CITY OF ONTARIO DEVELOPMENT ADVISORY BOARD

AGENDA

August 5, 2024

B. ENVIRONMENTAL ASSESSMENT AND DEVELOPMENT PLAN REVIEW FOR FILE NO. PDEV23-042: A public hearing to consider a Development Plan to construct a non-stealth wireless telecommunications facility on an existing Southern California Edison (SCE) tower located at 3791 South Archibald Avenue, within the UC (Utility Corridor) zoning district. The project is categorically exempt from the requirements of the California Environmental Quality Act (CEQA) pursuant to Section 15301 (Class 1, Existing Facilities) of the CEQA Guidelines. This application introduces no new significant environmental impacts. The proposed project is located within the Airport Influence Area of Ontario International Airport and was evaluated and found to be consistent with the policies and criteria of the Ontario International Airport Land Use Compatibility Plan; (APN: 0218-771-63) **submitted by Verizon Wireless.**

Exhibit C: LANDSCAPE PLAN

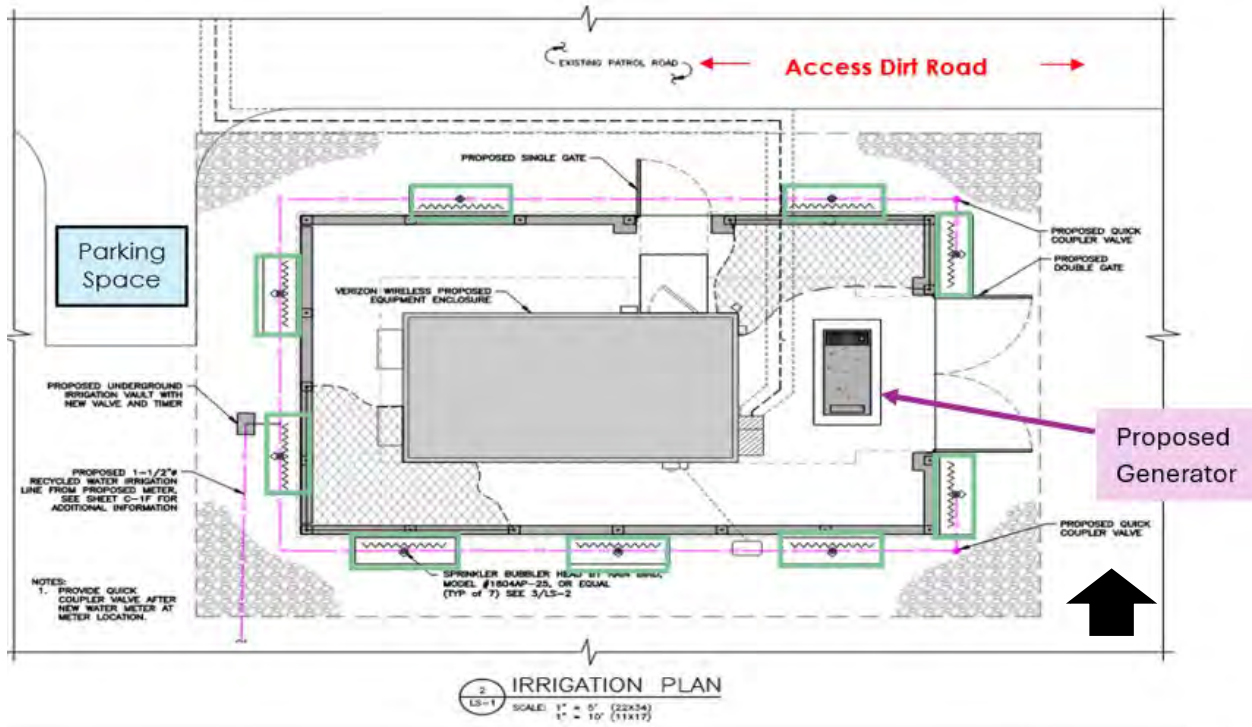
1. Replace proposed DG walkway with a landscape planter to screen the enclosure; plant material such as Ligustrum, Pittosporum, and Rhamphiolepis sized in 5 Gal and spaced 3' on center, allowing for access areas and doors.
2. Proposed Irrigation shall include isolation valves, strainer, master valve, flow sensor, etc.
3. Show concrete mowstrips to separate ownership or between maintenance areas.
4. Note for compaction to be no greater than 85% in landscape areas. All finished grades at 1 1/2" below finished surfaces.
5. Landscape construction plans shall meet the requirements of the Landscape Development Guidelines. See <https://www.ontarioca.gov/Planning/Landscape>
6. After a project's entitlement approval, the applicant shall pay all applicable fees at a rate established by the resolution of the City Council.

(b) Replace the proposed DG (decomposed granite) walkway with a landscape planter to provide public screening to the block enclosure.
